# SERVICE BULLETIN No. 292 72 2236

**Subject:**  
Module M01 - Modification to the roughness on the starter gear and to the module M01 axial clearance.  
Modification TU 236.

APPLICABLE ENGINE / VARIANT(S)	EFFECTIVITY CODE	MAINTENANCE LEVEL	CONDITION OF APPLICATION	EFFECT ON OPERATION
ARRIEL 2 B, B1, B1A, C, C-PM, C1, C2, C2-CG, D, E, H, L2, N, S1, S2	2-A-3	1, 2, 3	Application upon customer request	Replacement of module M01
		4	Application upon first return to an approved Repair Center, if the repair/overhaul gives access to the starter gear

**Figure 1**
**1.1.2. Analysis**

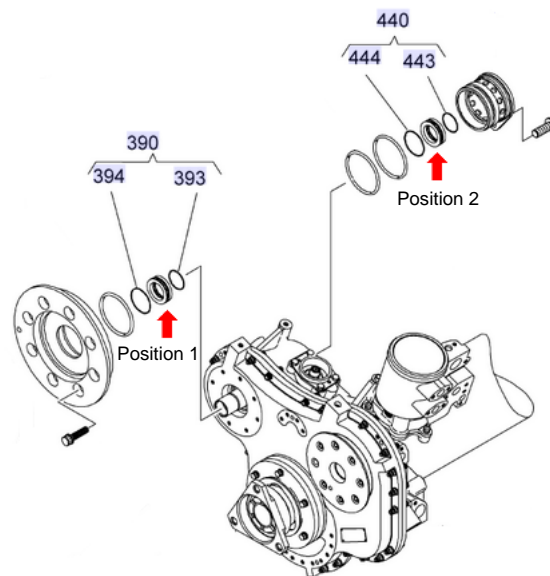
Operators of ARRIEL 2 engines reported oil leaks on the magnetic seal assemblies (See figure 1, Position 1 and Position 2) installed on the starter gear of the accessory gearbox module (Module M01).

Investigations of magnetic seal assemblies installed on the starter gear done by Safran Helicopter Engines (and shared with the supplier of these magnetic seal assemblies) determined that the origins of the observed leaks are different. They are related among others to:

- a separation of the two rings that make the magnetic seal assembly. This separation can be the result of an excessive axial clearance on the starter gear line.
- damage to the o-ring of the rotor section of the magnetic seal assembly. This damage can be the result of a not sufficient rotational drive capability of the friction ring of the magnetic seal assembly. It is possible to get a better drive capability with a higher roughness on the starter gear.

**Figure 2**
**1.2. Approval**

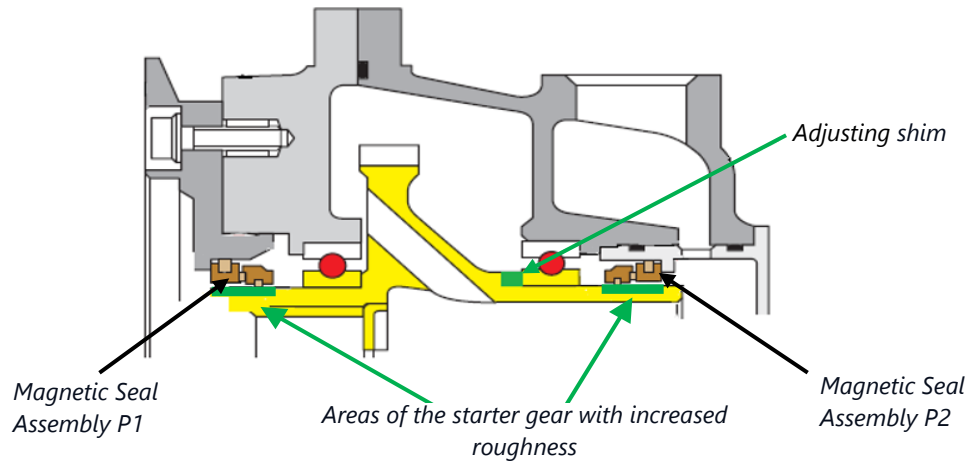
Modification TU 236 (see figure 2):

- limits the maximum clearance of the starter gear line by introducing an adjusting shim.
- increases the roughness of the starter gear surfaces opposite the magnetic seals.
